FACILITY ASSESSMENT REPORT MAPLE VALLEY SCHOOL DISTRICT BUFFALO SCHOOL APRIL 2016

FACILITY SUMMARY

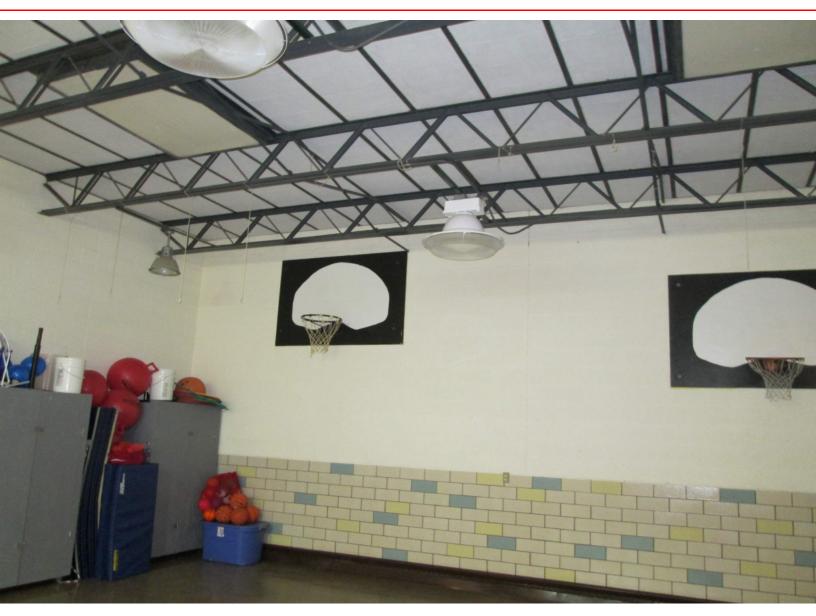
2012 IBC: SECTION 903.2.3 GROUP E

- An automatic sprinkler system shall be provided for Group E occupancies as follows:
 - Throughout all Group E fire areas greater than 12,000 square feet in area.

Corrective Action: Provide automatic sprinkler system throughout existing building. Provide smoke detection in multi-purpose room. Replace light fixtures with energy efficient fixtures.

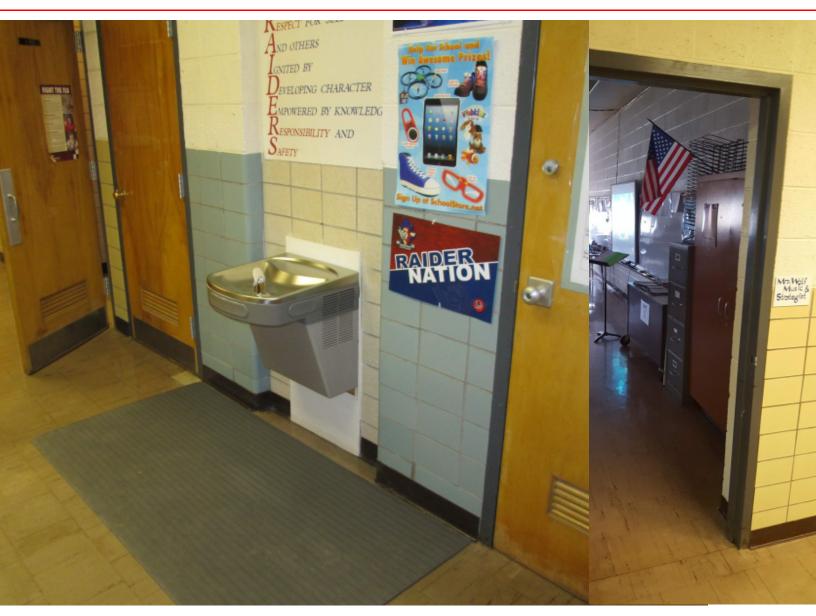
2012 IBC: SECTION 1109.2 TOILET AND BATHING FACILITIES

- Each toilet room and bathing room shall be accessible. At least one of each type of fixture, element, control or dispenser in each accessible toilet room and bathing room shall be accessible.

Corrective Action: Provide accessible toilet compartments and add fixtures to meet required plumbing counts.

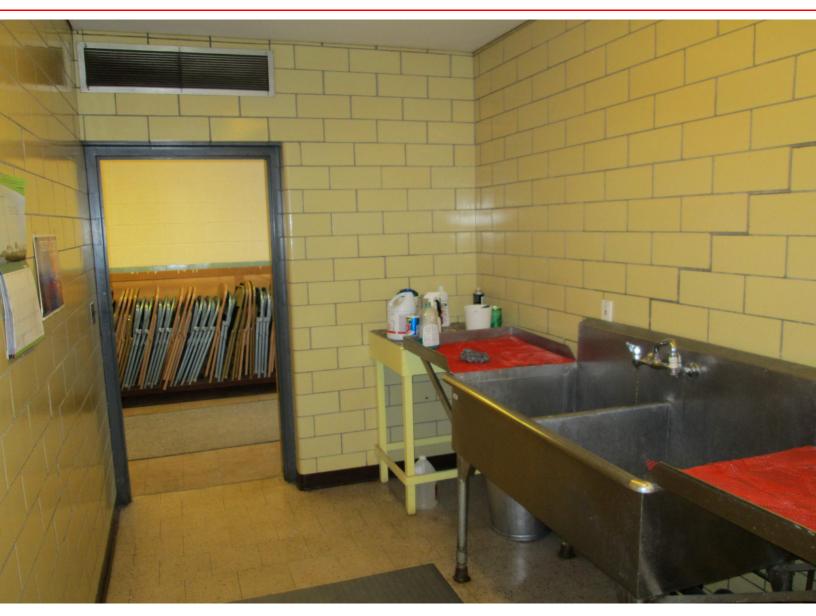
2012 IBC: SECTION 1110.1 Signs

- Required accessible elements shall be identified by the International Symbol of Accessibility.

Corrective Action: Provide signage indicating accessibility provisions at all entrances, and rooms required to be accessible.

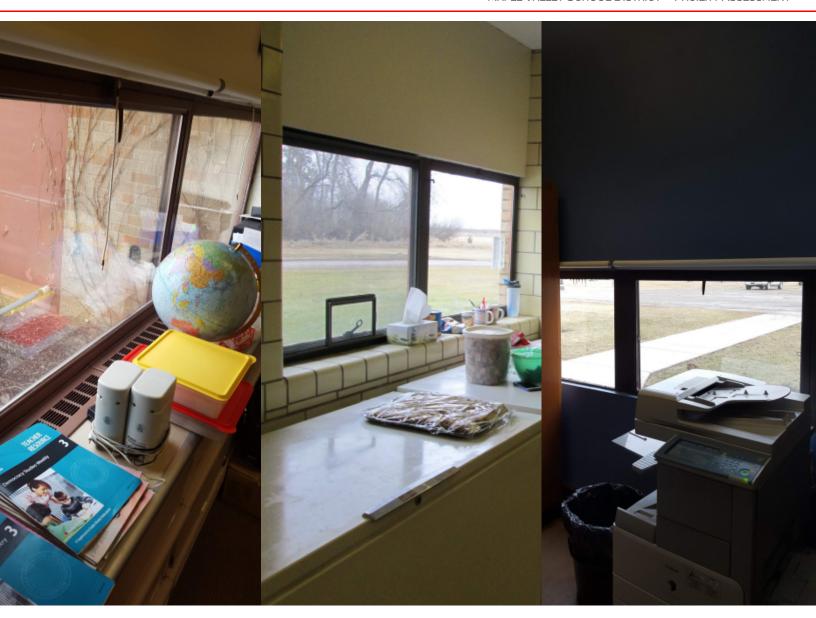
Corrective Action: Displacement and cracking of tile in kitchen suggests movement in wall and possible structural deficiency.

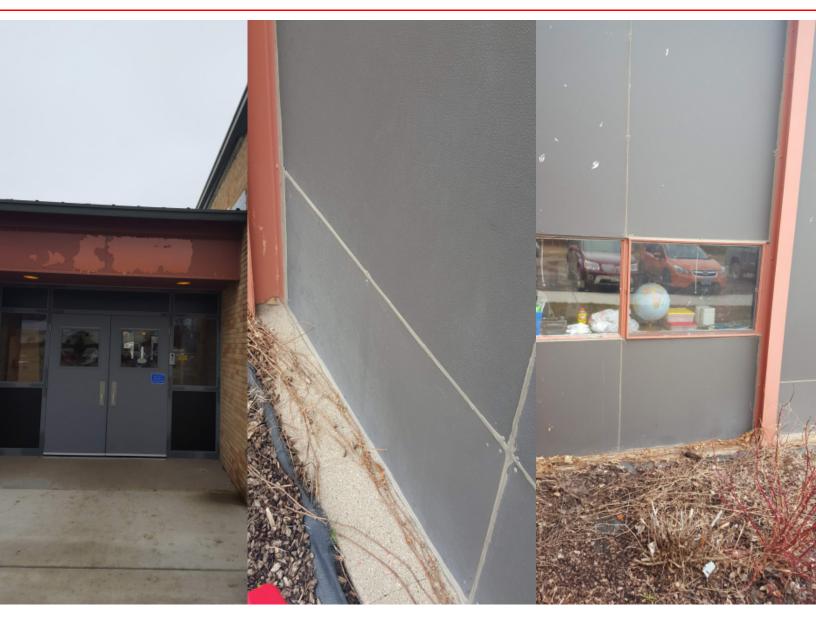
Corrective Action: Exterior walls, roof and windows of entire building provide poor insulation and should be corrected to provide a comfortable and efficient environment. All windows are single pane are in need of replacement.

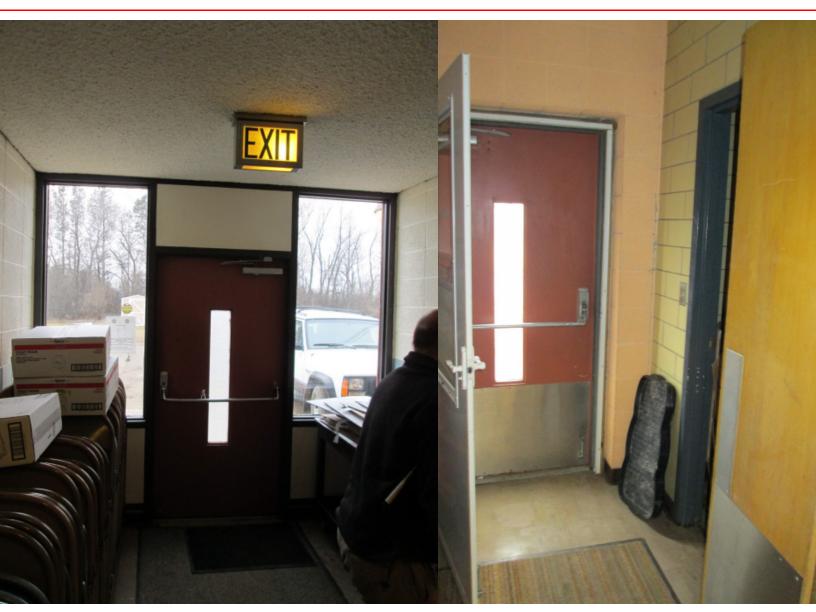
Corrective Action: Exterior finishes are in need of replacement. Metal panels are deteriorated and sealants are susceptible to leakage and air infiltration. All windows are single pane are in need of replacement.

Corrective Action: Replace exterior doors with updated hardware.

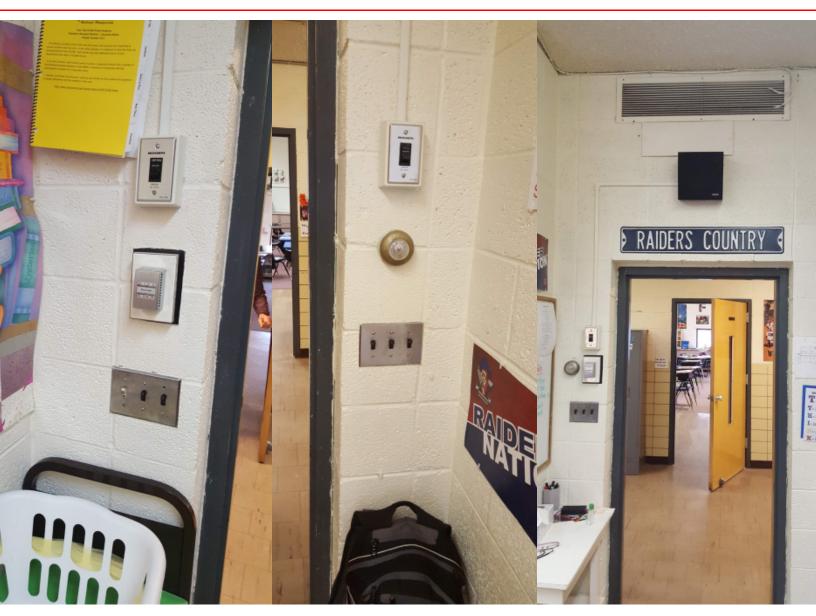
2012 IBC: SECTION 1104.1 SITE ARRIVAL POINTS

- Accessible routes within the site shall be provided from public transportation stops; accessible parking; accessible passenger loading zones; and public streets or sidewalks to the accessible building entrance served.

Corrective Action: Provide paved parking for designated accessible parking.
